MPLAB® SNAP AVR UPDI/PDI/TPI Interface Modification

Figure 1

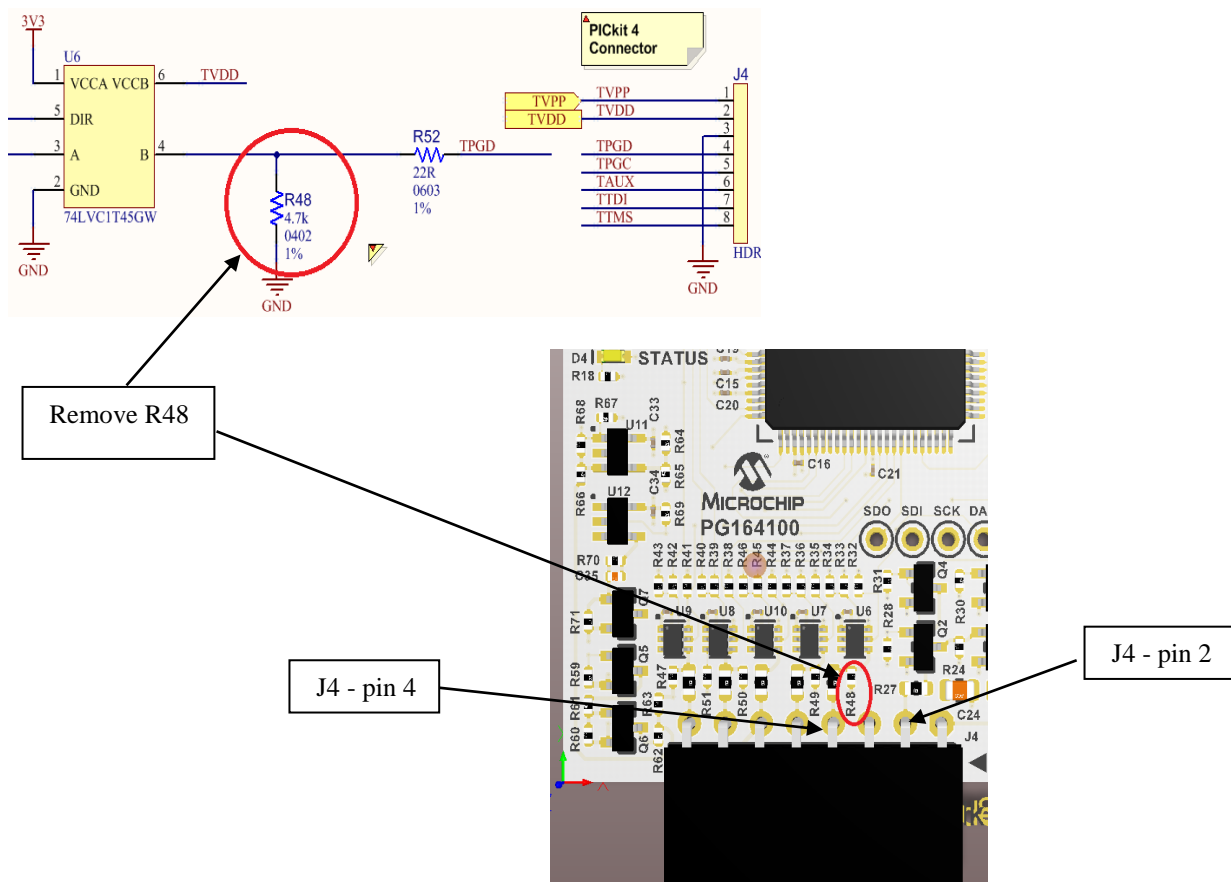
Symptom: Programming and debugging fails with AVR microcontroller devices that use the UPDI/PDI/TPI interfaces. MPLAB SNAP, Assembly #02-10381-R1 requires an external pull-up resistor for AVR microcontroller devices that use these interfaces.

Problem: AVR microcontroller devices that use the UPDI/PDI/TPI interfaces require the idle state of inactivity to be at a logic high level. Internally, the AVR devices have a weak (50-100K) pull-up resistor that attempts to keep the line high. An external and stronger pull-up resistor may be enough to mitigate this issue and bring voltages to acceptable VDD levels. In some cases, this may not be enough and the pull-down resistor that is part of the ICSP protocol can be removed for these AVR microcontroller applications.

Solution: If most of the applications are AVR-centric, consider removing the R48 resistor as shown below. This completely isolates any loading on the programming data line. Additionally, a pull-up resistor to VDD in the range of 1K to 10K should be used for robustness. Pin 4 of J4 is the TPGD data line used for ICSP interfaces and it also doubles as the DAT signal for UPDI/PDI and TPI interfaces. The pull-up resistor can be mounted directly from TVDD (J4-2) to TPGD/DAT (J4-4). Alternatively, the resistor can be mounted on the application side of the circuit for convenience.
